## **Access Compliance Report Public Rights-of-Way** (Curb Ramps)

Intersection ID: 44012 Main Street: BRADWELL DR **Cross Street: LANGHAM CT** Location: SE ADA ID: 21490FEC0B65 Ramp Type: PerpDiag Initial Pass/Fail: Fail **Overall Compliance: No** Severity Score: 33.75

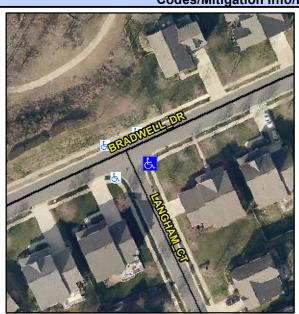
Street 1 Name Stop Condition-Street 2 Street 2 Name Stop Condition-Street 1 **BRADWELL DR** None **LANGHAM CT** StopSign Possible Solutions: Remove & Replace Curb Ramp With **Two New Directional Ramps or** Equivalent. Surveyor Notes: N/A PROW/ADA: Not Found, R304.5.1, R304.2.2

Field Measurements/Component Compliance						
	Compliance Description		Data	Compl	iance Description	Data
	N/A	Ramp Length (in)	49.5	No	Ramp Slope (%)	13.0
	No	Ramp Width (in)	36.0	Yes	Ramp XSlope (%)	1.3
	N/A	Flare Type LT	N/A	N/A	Flare Type RT	N/A
	N/A	Flare Slope LT (%)	N/A	N/A	Flare Slope RT (%)	N/A
	N/A	Flare Traversable LT?	N/A	N/A	Flare Traversable RT?	N/A
	N/A	Landing Length (in)	N/A	N/A	DWS Provided?	N/A
	N/A	Landing Width (in)	N/A	N/A	DWS Contrast?	N/A
	N/A	Landing Slope (%)	N/A	N/A	DWS Length (in)	N/A
	N/A	Landing X Slope (%)	N/A	N/A	DWS Full Width?	N/A
	N/A	Landing Curb? (Y/N)	N/A	N/A	DWS Offset (in)	N/A
	N/A	Shared Landing?	N/A			
	N/A	Gutter Ponding?	N/A	N/A	Gutter Slope (%)	N/A
	N/A	Gutter Lip Ht (in)	N/A	N/A	Gutter X Slope (%)	N/A
	N/A	Painted X Walk1?	No	N/A	Painted X Walk2?	No
		X Walk 1 Direction	To N		X Walk 2 Direction	To W
	N/A	X Walk 1 Width (in)	N/A	N/A	X Walk 2 Width (in)	N/A
		X Walk 1 Slope (%)	3.6		X Walk 2 Slope (%)	1.4

X Walk 1 X Slope (%)	2.6		X Walk 2 X Slope (%)	2.3
	N/A	Ramp inside XWalk1?	N/A	N/A	Ramp inside XWalk2?	N/A
		Road Slope (%)	1.0	N/A	Clear Space?	N/A
		Road X Slope (%)	2.2	N/A	Clear Space to XWalk (in)	N/A
	N/A	Any Obstructions?	N/A	N/A	Storm Grate/Utility Hazard?	N/A
		Obstruction Type			Storm Grate/Utility Type	
			N/A			N/A
				Yes	Surface Condition? (G/P)	Good
1		The same of the sa
